Access Compliance Report

Public Rights-of-Way

Intersection ID: 44275	Main Street: JOSEPH_HOWARD_CT	Cross Street: BRITNI_DAYLE_DR	Location: S
ADA ID: DA7DF2C03BE0	Ramp Type: PerpDiag	Initial Pass/Fail: Fail	Overall Compliance: No
		Severity Score: 22.5

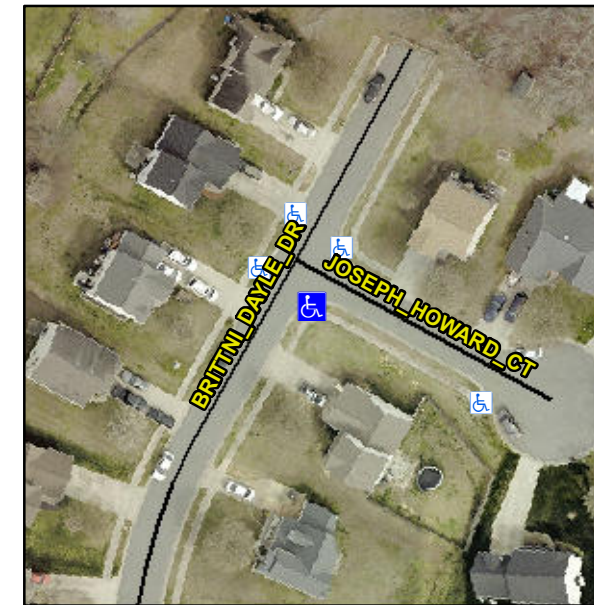
Not Found, R304.5.1, R304.2.2, R304.5.3

Compliance	Description	Data	Compliance	Description	Data
N/A	Ramp Length (in)	47.0	No	Ramp Slope (%)	8.4
No	Ramp Width (in)	46.5	No	Ramp XSlope (%)	3.2
N/A	Flare Type LT	N/A	N/A	Flare Type RT	N/A
N/A	Flare Slope LT (%)	N/A	N/A	Flare Slope RT (%)	N/A
N/A	Flare Traversable LT?	N/A	N/A	Flare Traversable RT?	N/A
N/A	Landing Length (in)	N/A	N/A	DWS Provided?	N/A
N/A	Landing Width (in)	N/A	N/A	DWS Contrast?	N/A
N/A	Landing Slope (%)	N/A	N/A	DWS Length (in)	N/A
N/A	Landing X Slope (%)	N/A	N/A	DWS Full Width?	N/A
N/A	Landing Curb? (Y/N)	N/A	N/A	DWS Offset (in)	N/A
N/A	Shared Landing?	N/A			
N/A	Gutter Ponding?	N/A	N/A	Gutter Slope (%)	N/A
N/A	Gutter Lip Ht (in)	N/A	N/A	Gutter X Slope (%)	N/A
N/A	Painted X Walk1?	No	N/A	Painted X Walk2?	No
	X Walk 1 Direction	To NE		X Walk 2 Direction	To NW
N/A	X Walk 1 Width (in)	N/A	N/A	X Walk 2 Width (in)	N/A
	X Walk 1 Slope (%)	4.5		X Walk 2 Slope (%)	2.8
	X Walk 1 X Slope (%)	0.4		X Walk 2 X Slope (%)	3.5

Remove & Replace Curb Ramp With Two New Directional Ramps or Equivalent.
